FORM FOR SUBMISSION OF REQUESTS FOR DEVIATION PRIOR TO SUBMITTING REQUEST
FOR ISSUANCE

CDM: Form for submission of requests for deviation prior to submitting request for issuance (Version 01) <i>(To be used by the DOE for requesting a deviation prior to submitting request for issuance)</i>	
Name of the entity (DOE) submitting this form	TÜV NORD Cert GmbH
Project Ref./Title of the project activity	Anguor Hydropower Project in China (0886)
Title/Subject (give a short title or specify the subject of your submission, maximum 200 characters):	Request for deviation from the monitoring plan due to joint meter reading
Specify the monitoring period for which the request is valid:	From March 30 th 2010 to June 17 th 2010
Date and signature for the DOE	2012-02-07 Rainer Winter 
Description of the request for deviation	
Please use the space below to describe the deviation and substantiate the reason for requesting a deviation from provisions of registered monitoring plan.	
>> During on-site visit of the fourth verification period the DOE observed that the project's situation deviated from the provision of the registered monitoring plan. Due to the fact that two more power plants were connecte

Figure 1: The situation in the registered PDD

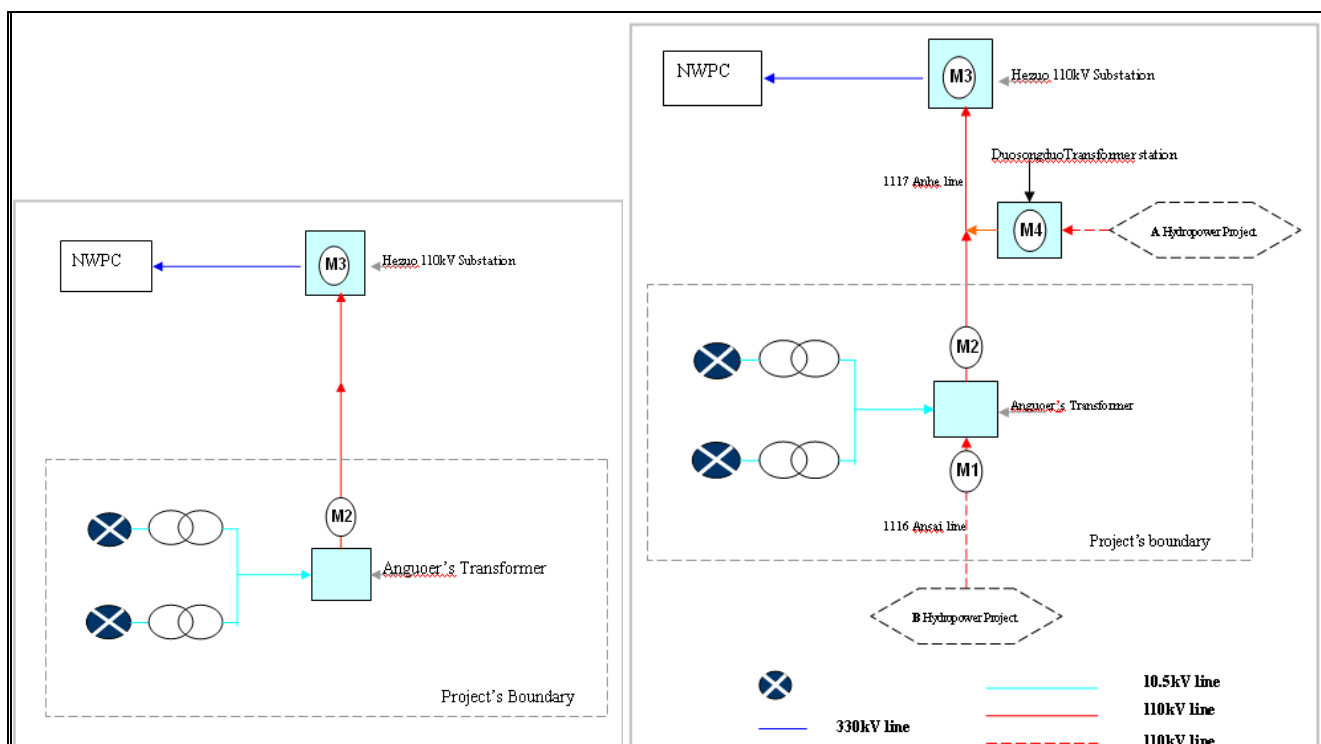
The Figure 1 indicates the project's monitoring situation in the registered PDD, which covers the first and the second monitoring periods. For the metering purpose, the main meter (M3) was installed in the Hezuo 110kV substation for recording electricity data which were adopted to issue payments and the meter (M2) was installed at high voltage side of Anguor transformer station for backing-up purpose.

During the on site visit for the fourth periodic verification, TÜV NORD has observed a deviation

For the 4th monitoring period, the meter M3, M4 and M1 were used as the main meters. This has been assessed as the most plausible and accurate way of determining the net electricity for the proposed project activity.

The Project B was connected to the grid on 2009-01-19 via transformer station of the proposed project through 1116 Ansai line as per contract between the grid operator Gansu Electrical Power Company and the project owner, which is the same project owner as of the proposed project, dated 2008-12-16. The meter M1 is defined as the main meter to issue the electricity balance sheet and payment for the hydropower project B.

The Project A which is owned by a different entity was connected to the grid in May 2009 via Hezhou Substation through 1117 Anhe line according to the grid company notification: Gan Dian Si Ji [2006] No.158. The meter M4 is located at the Duosongduo Transformer Station and defined as the main meter for the hydropower project A.

It could be verified by TÜV NORD that there was no obstacle to calculate the emission reductions of the proposed project due to the reason that the grid company was responsible for providing electricity balance sheet by deducting M4's data from M3's. M3 is the joint meter for the proposed project, project A and project B.

The deviation which covers the 4th monitoring period does not require a revision of monitoring plan or the changes from the project activity as described in the registered project design document.

By means of on site visit and interviewing the project's technicians and the general manager, the DOE found out that the request for deviation is only applicable till 2010-06-17, in which the fourth monitoring period was from 2010-03-30 to 2010-06-17. After 2010-06-17, the monitoring system was changed permanently which was confirmed through on site checking and interviewing. As indicated in the figure 2 the meter M3, which is used to record generated electricity from project A, the proposed project (0886) and project B, located at Hezuo 110kV substation. However, it could be confirmed that the change in the meter arrangement is not permanent by checking the grid company's notification: Gan Dian Si Ji [2006] No.158. The document provides information that there will be a new substation which is named Duohe 330kV substation. It is further stated that this substation will be built and this CDM project no. 0886 will be connected to this newly-built substation (not to the old Hezuo 110kV substation) when it will be put into operation. As per the notification letter the main meter of this CDM project no. 0886 will be located in this newly-built substation. The actual implementation as stated above was checked and verified by the verification team through on site visit on 2011-09-14 to confirm that Duohe 330kV substation has been already put into operation. In addition, the verification team observed further modifications in the meter arrangement during the site visit of the 5th monitoring period and is already in the process of carrying out the request for revision of the monitoring plan of the 5th monitoring period, which means the deviation of the 4th monitoring period is not a permanent change.

With the deviation, meter M3, M4 and M1 were used as the main meters for the proposed project instead of only using meter M3 as in the registered PDD. The accuracies of M1 and M4 are on the same accuracy level as the meter M3 which is 0.2S as stated in table 4.

Considering two more meters the way to calculate net electricity fed into the grid by the proposed project changed accordingly. Please refer to the table below which clarifies the differences.
